EXISTING CONDITIONS and
DEMOLITION PLAN
1701 DISCIPLE DRIVE
JONESBORO, ARKANSAS
FOR
JOURNEY CHURCH

GRADING and DRAINAGE PLAN
1701 DISCIPLE DRIVE
JONESBORO, ARKANSAS
FOR
JOURNEY CHURCH

JOURNEY JONESBORO CHURCH
KIDS' EXPANSION
1701 disciple drive - jonesboro, ar 72401

**JOURNEY JONESBORO CHURCH
CLASSROOM ADDITION**
1701 disciple drive - jonesboro, ar 72401

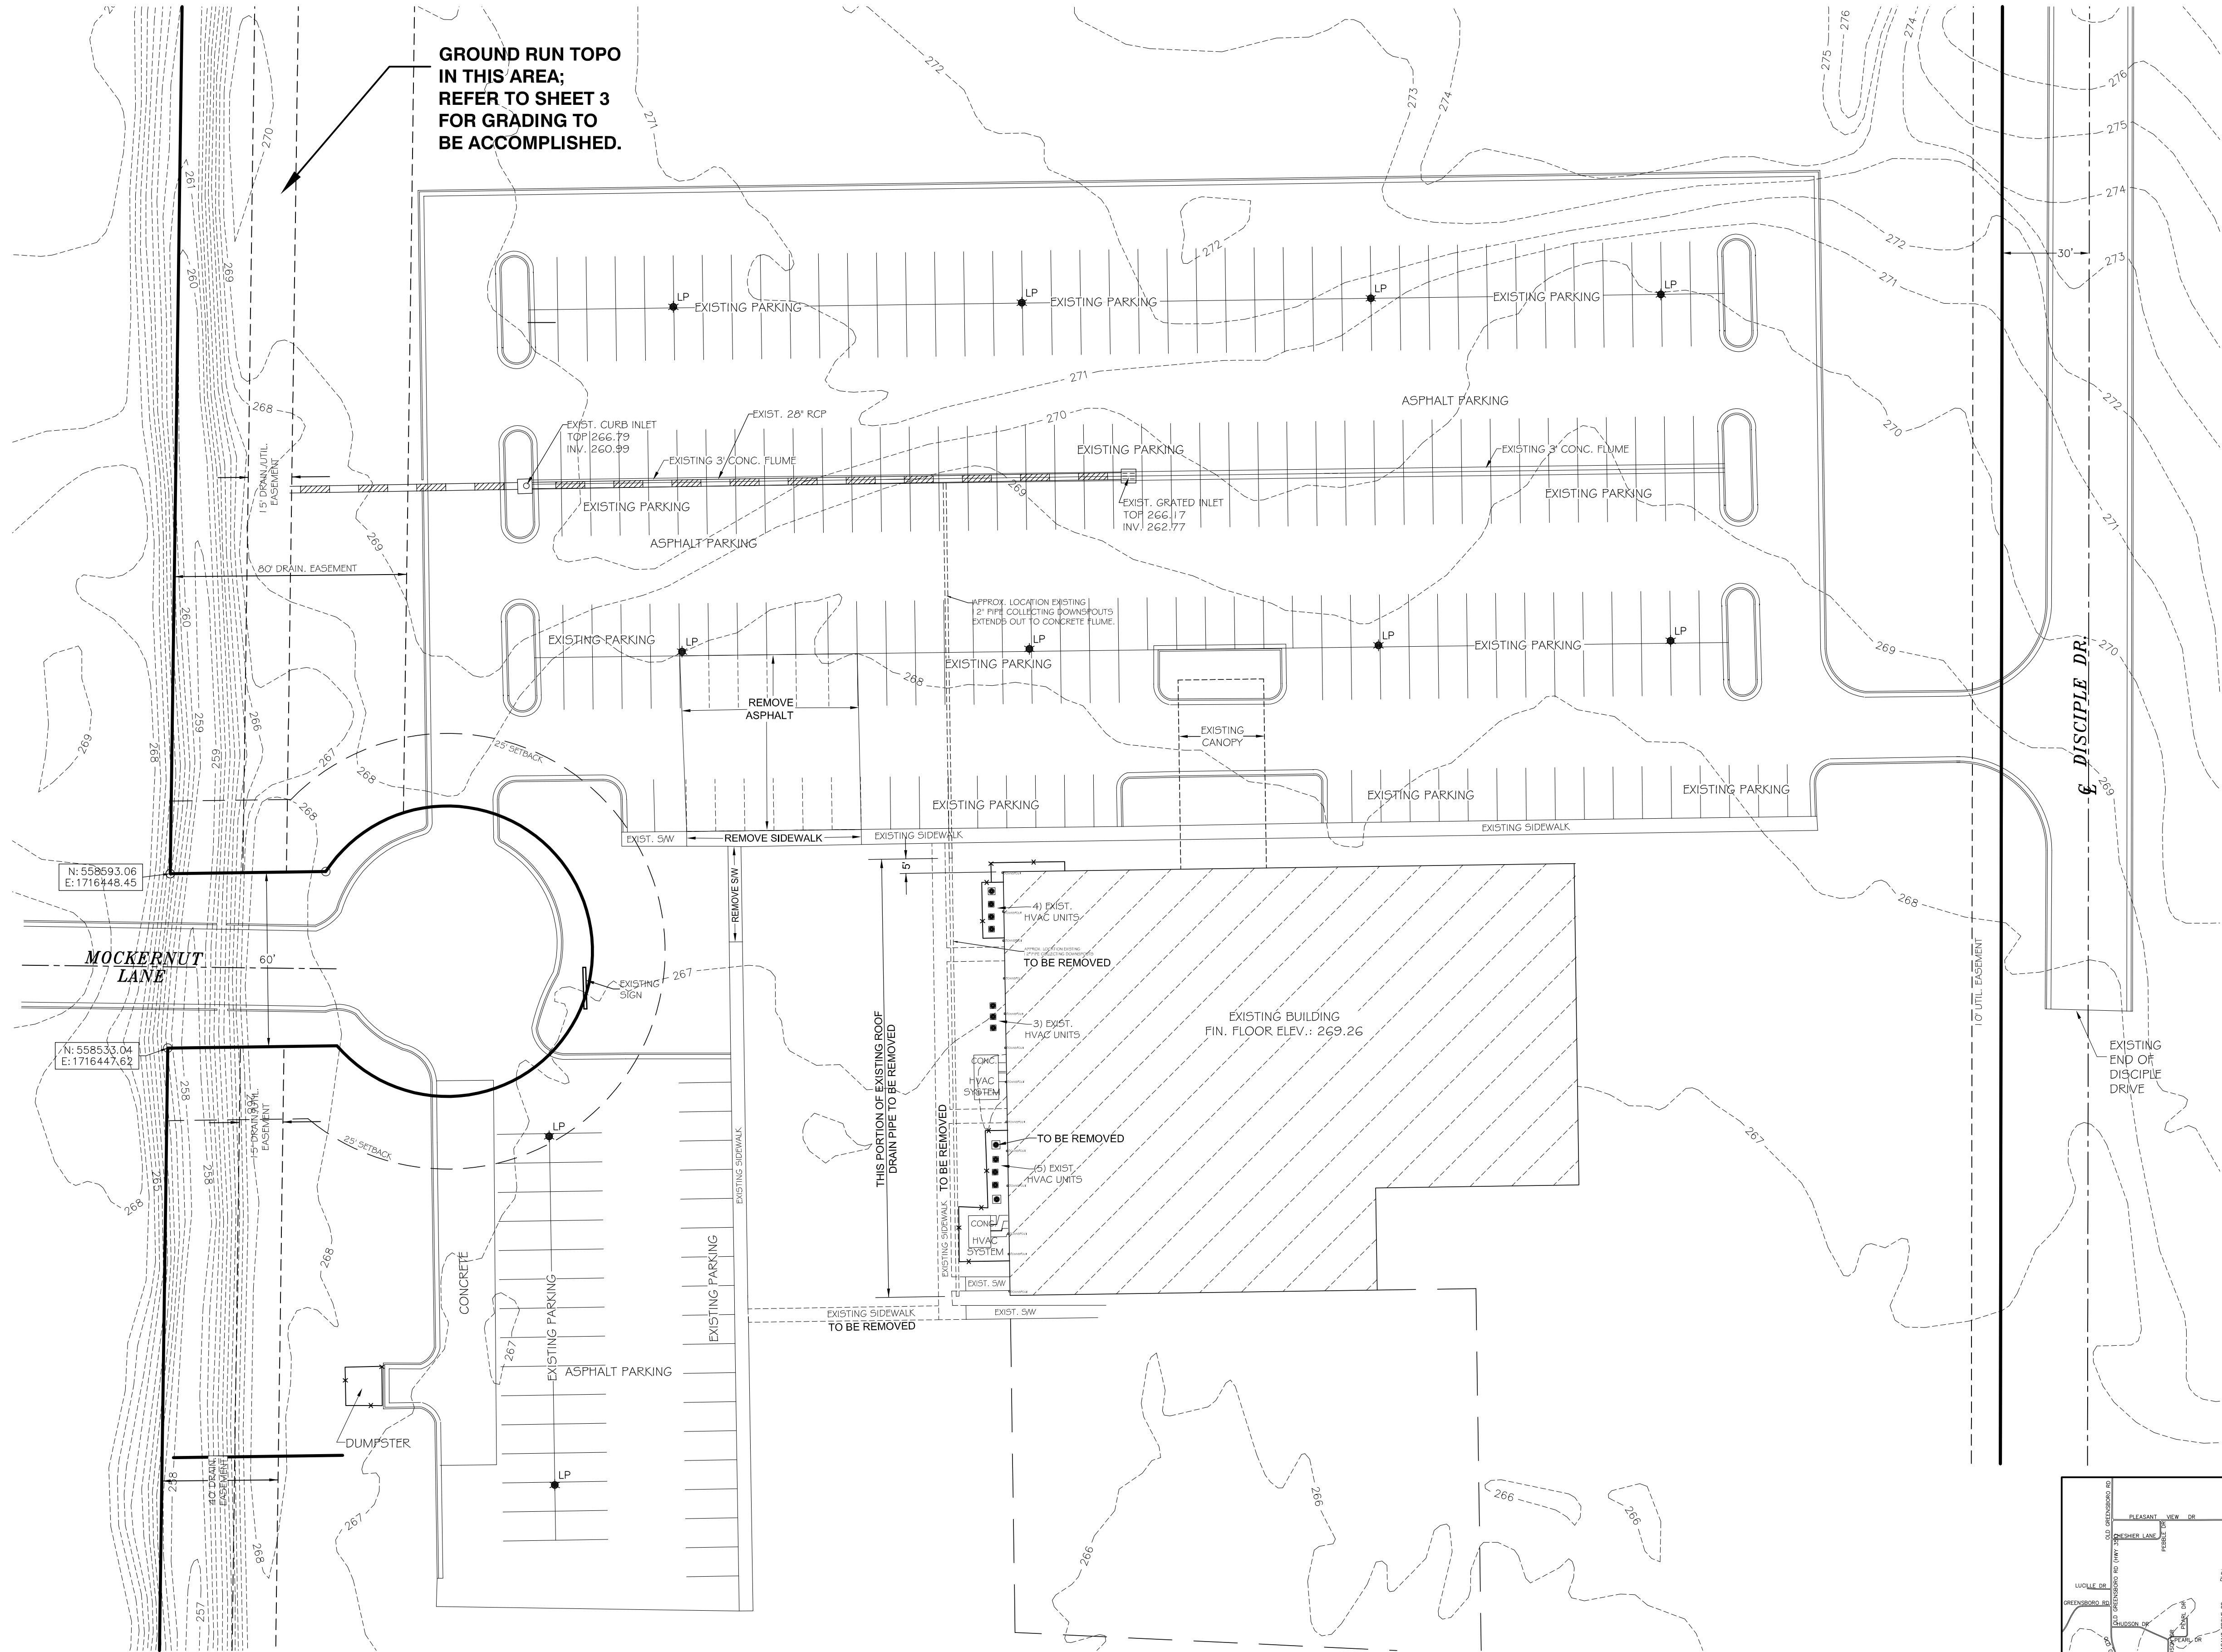
REVISED 7-31-19: PART OF ADDENDUM NO. 1
REVISED 7-25-19: EXISTING DRAINAGE PIPE ADDED
REVISED 7-24-19: ADDITIONAL TOPO, ADDED
PART OF ADDENDUM NO. 1

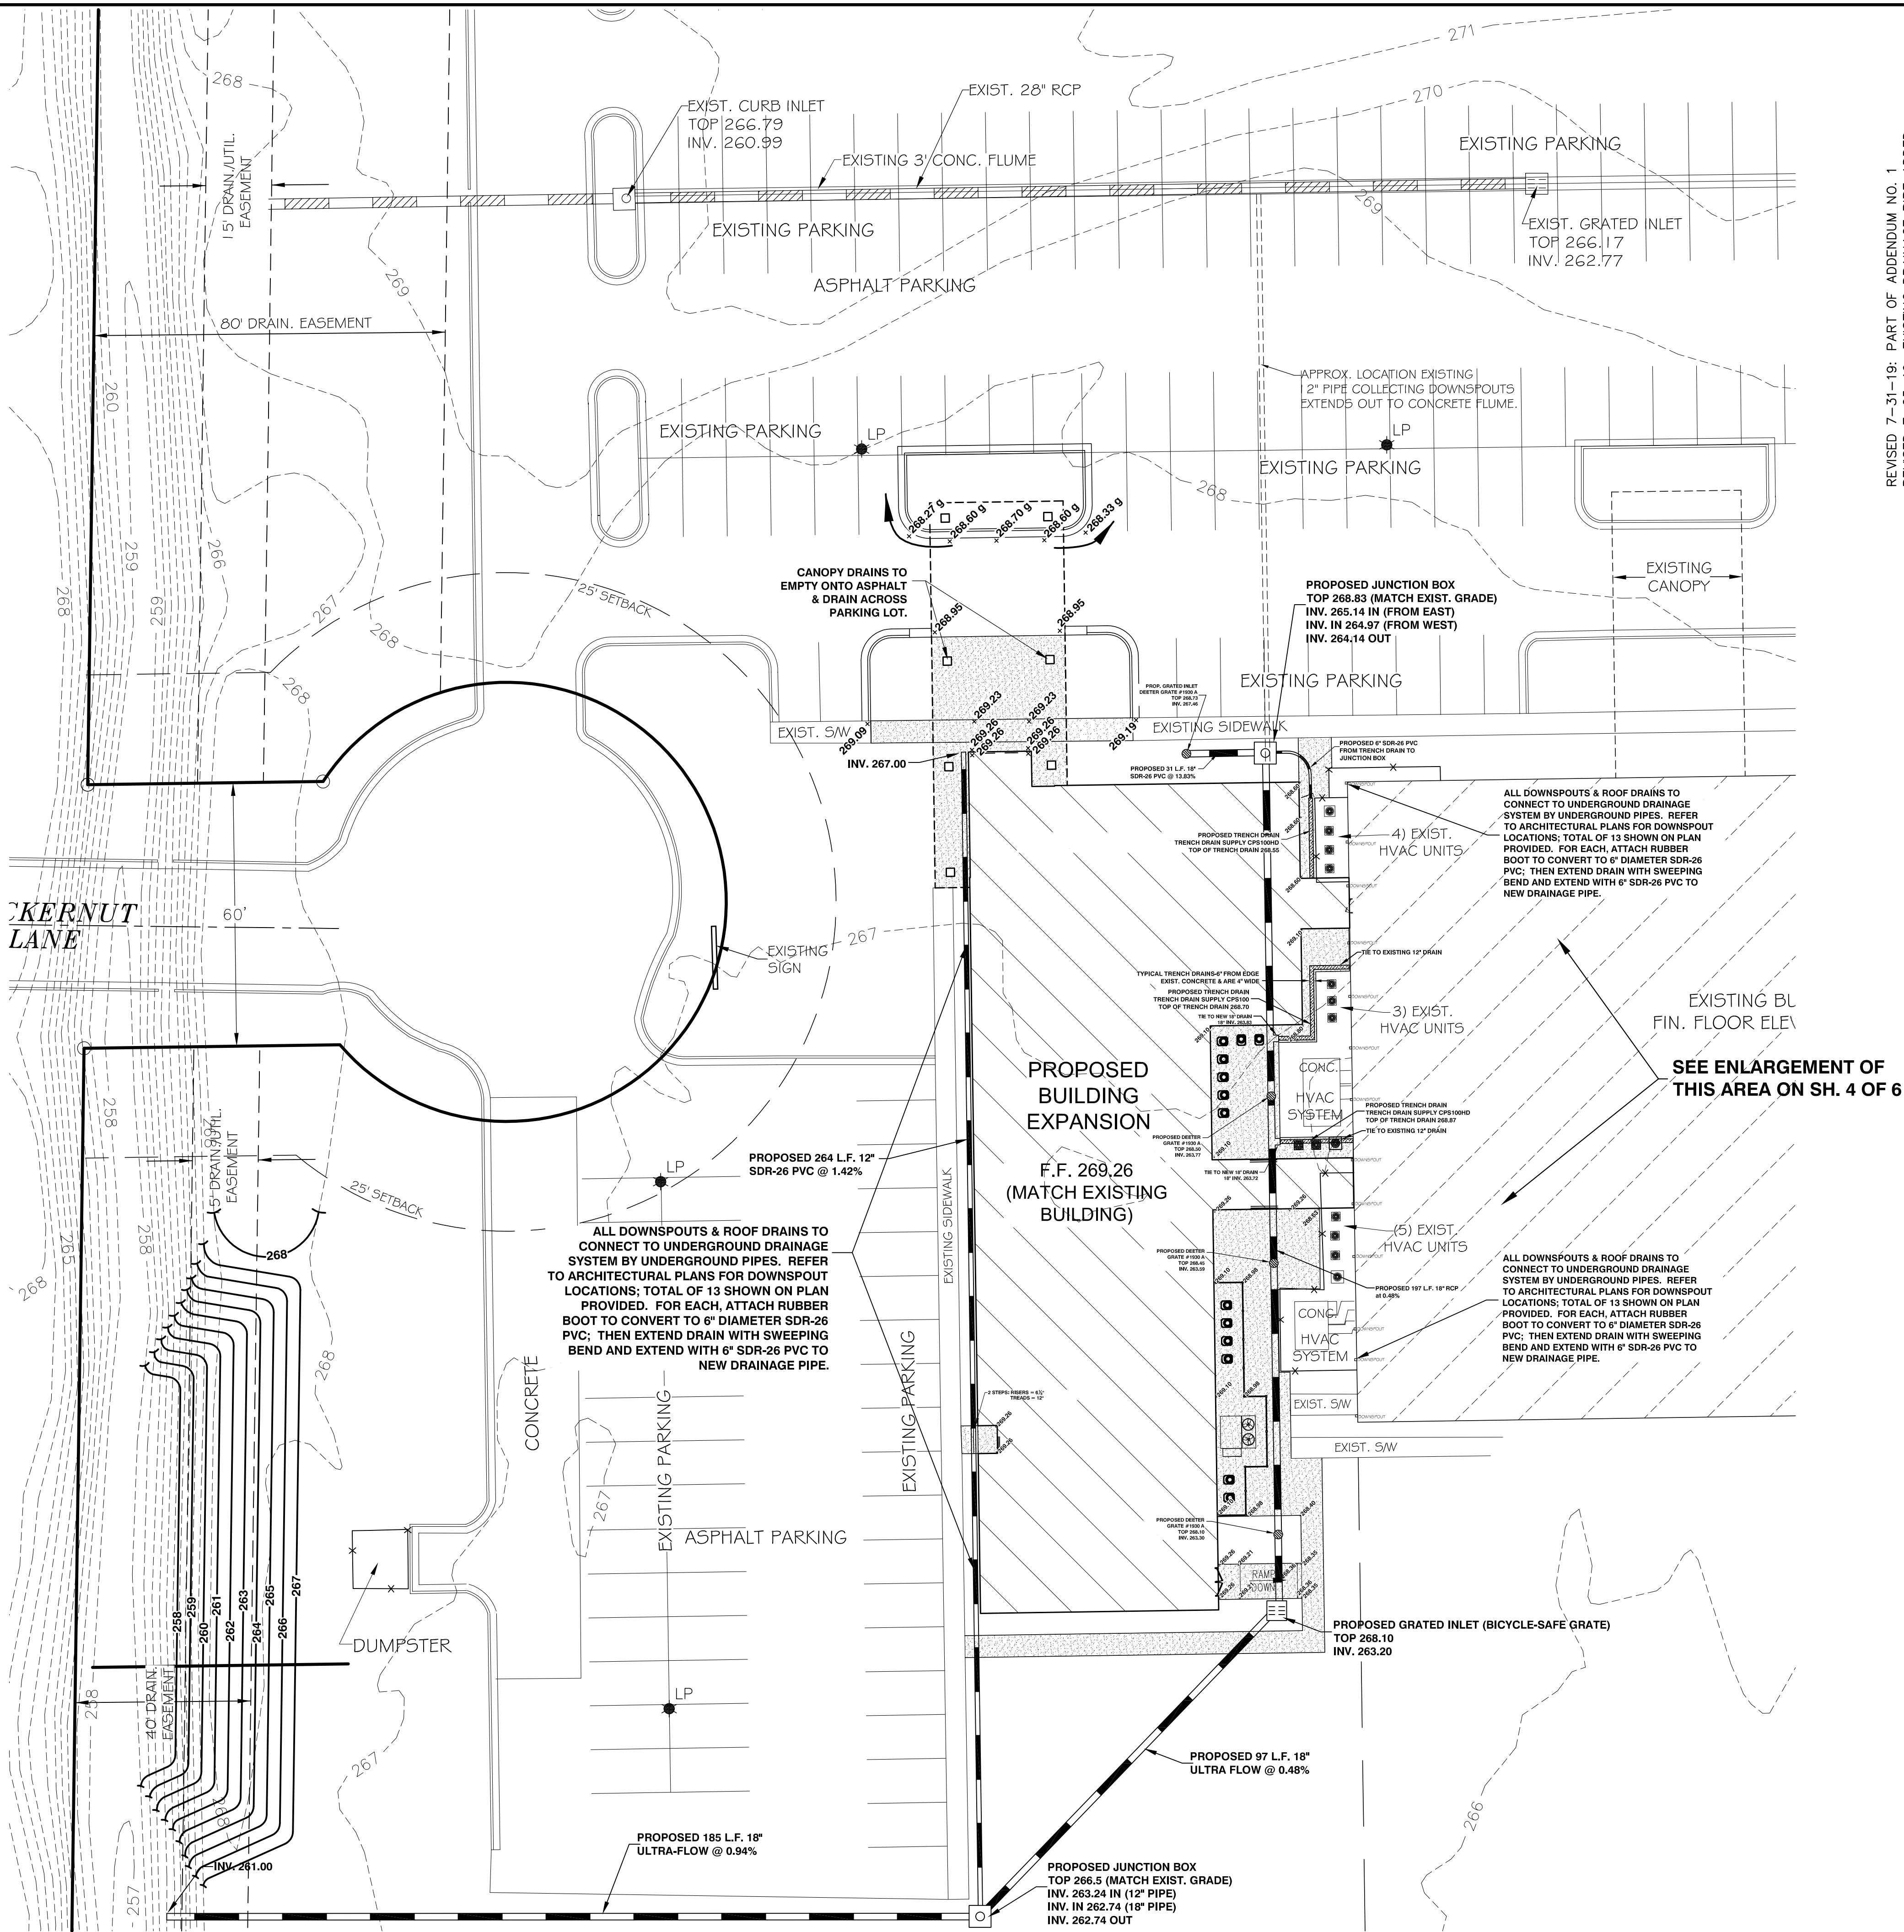
REVISED 7-31-19: PART OF ADDENDUM NO. 1
REVISED 7-25-19: EXISTING DRAINAGE PIPE ADDING
ADDITIONAL TOPO AND GRADING
LINES ADDED PART OF ADDENDUM NO. 1
REVISED 7-24-19: PART OF ADDENDUM NO. 1

SOIL & EROSION CONTROL PLAN
1701 DISCIPLE DRIVE
JONESBORO, ARKANSAS
FOR
JOURNEY CHURCH

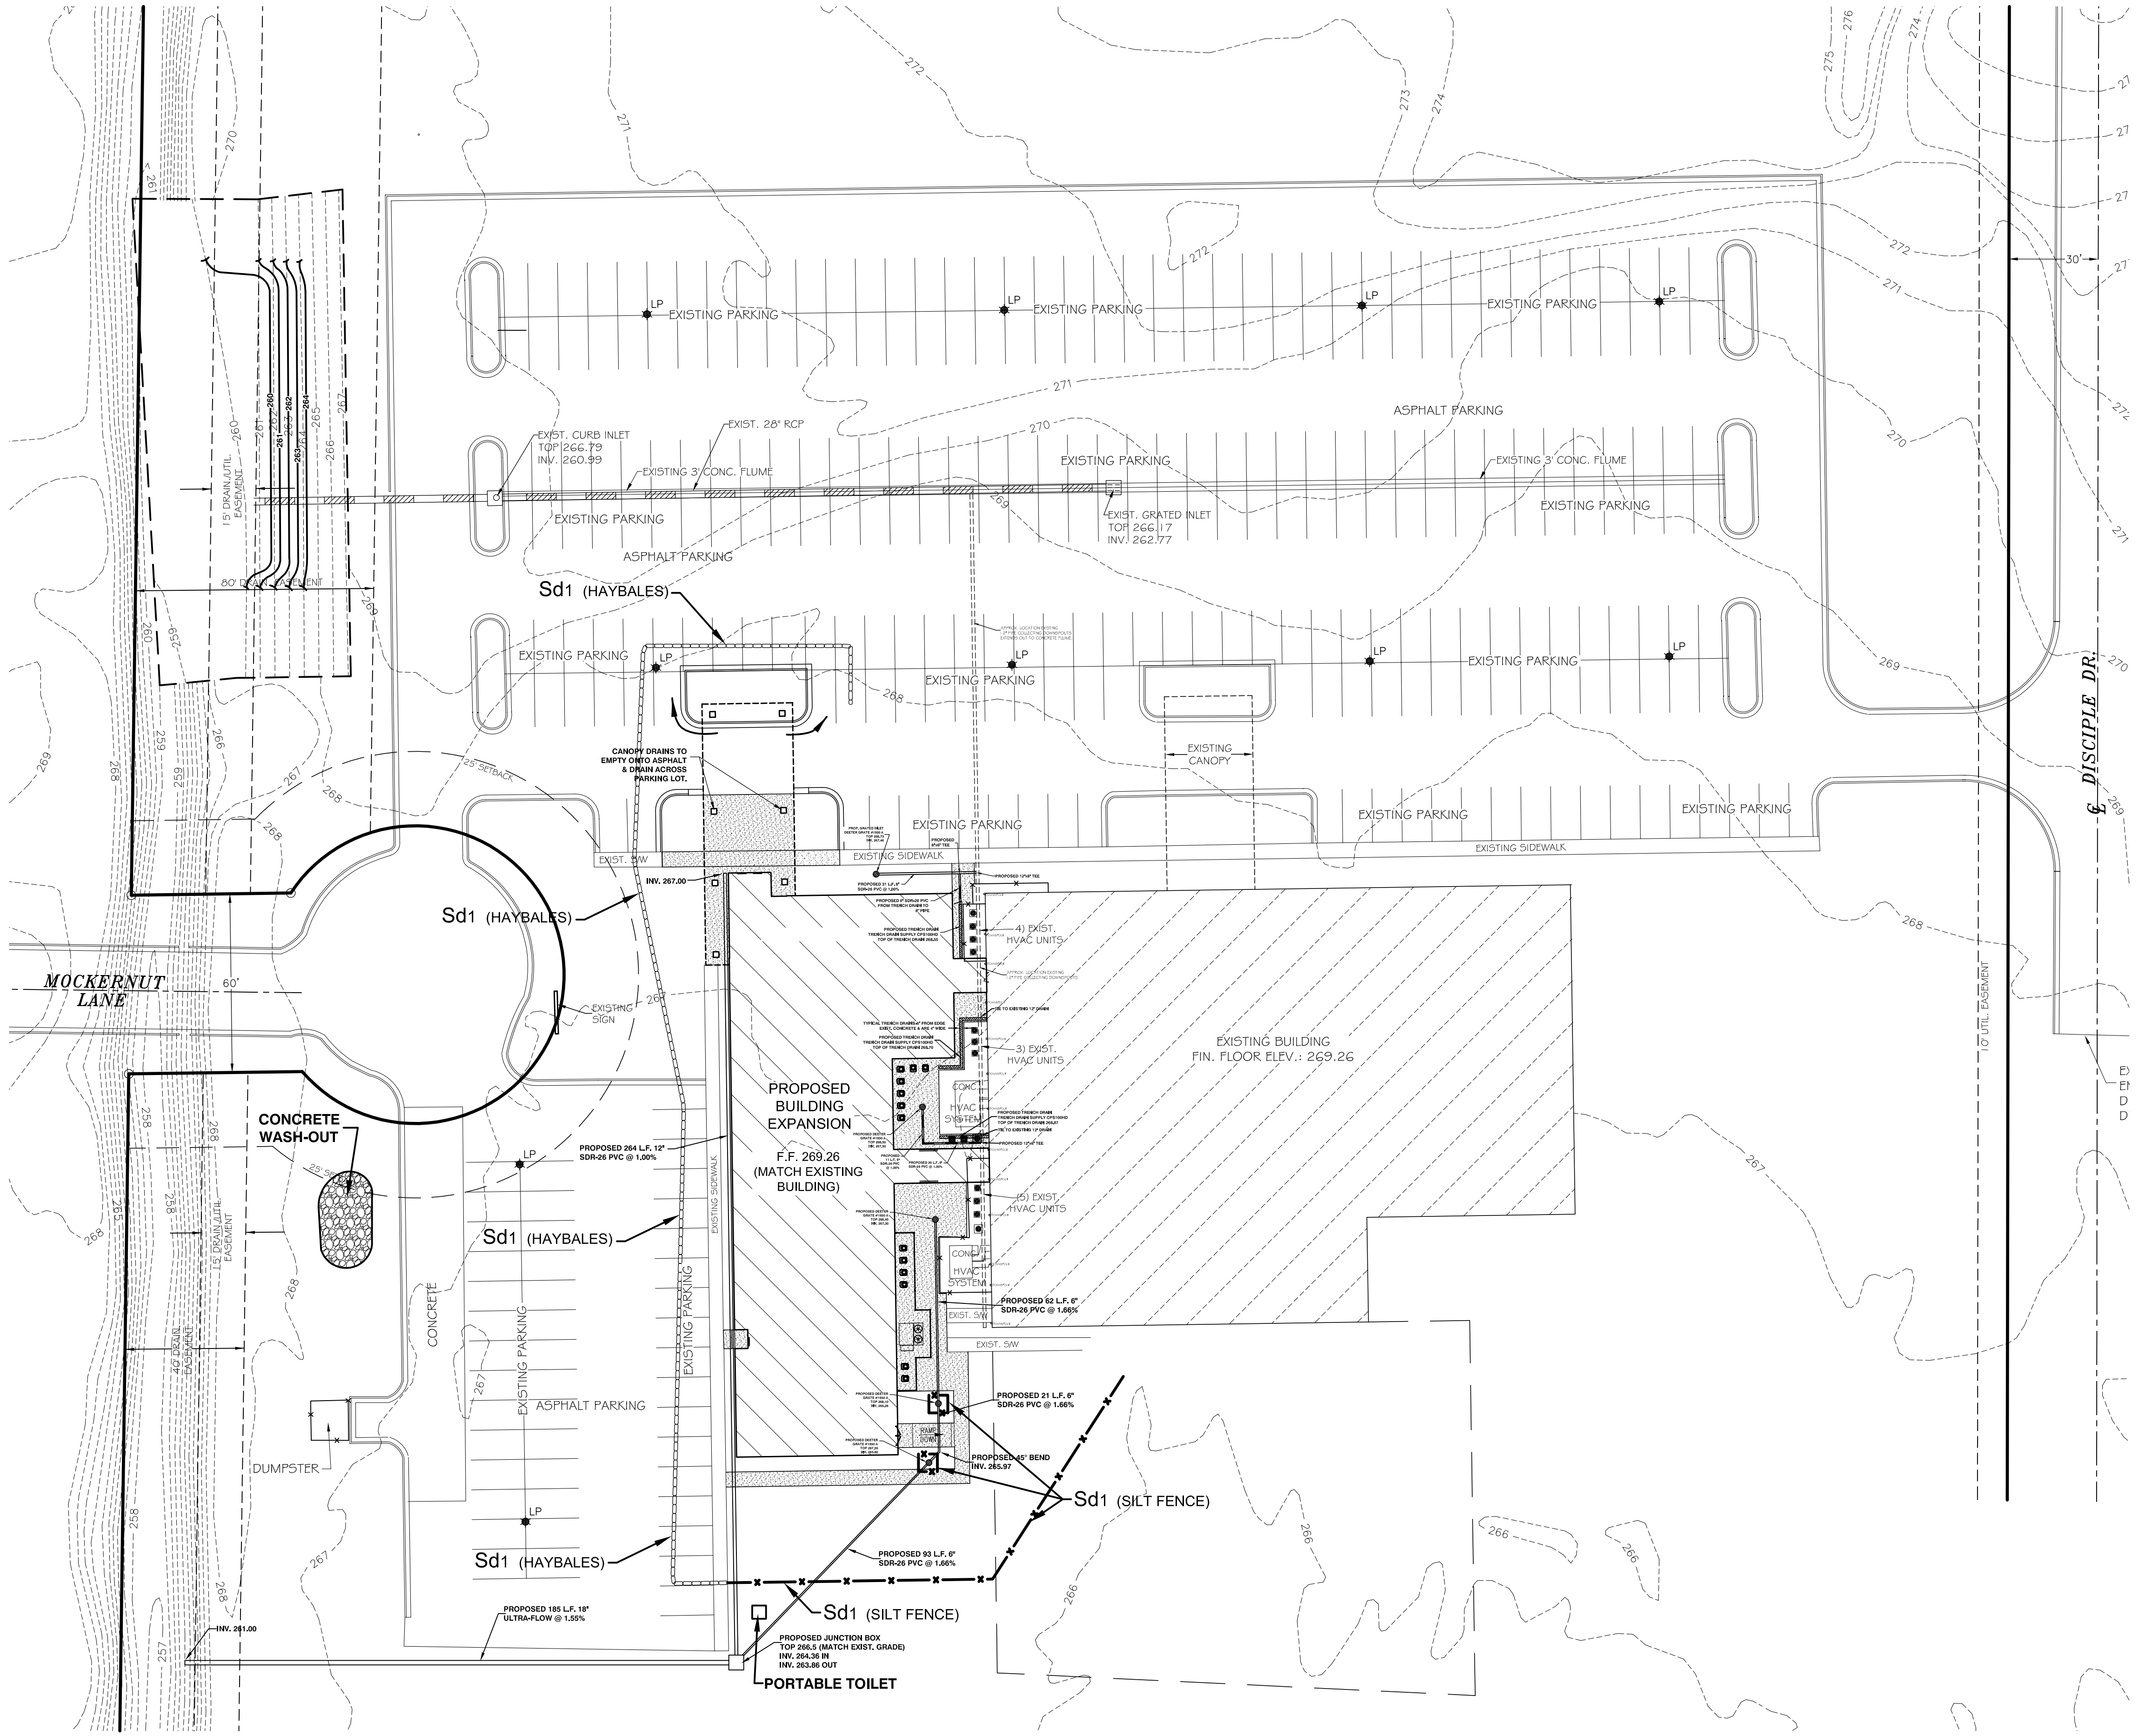
REVISED 7-24-19: ADDITIONAL TOPO AND GRADING LINES ADDED - PART OF ADDENDUM NO. 1
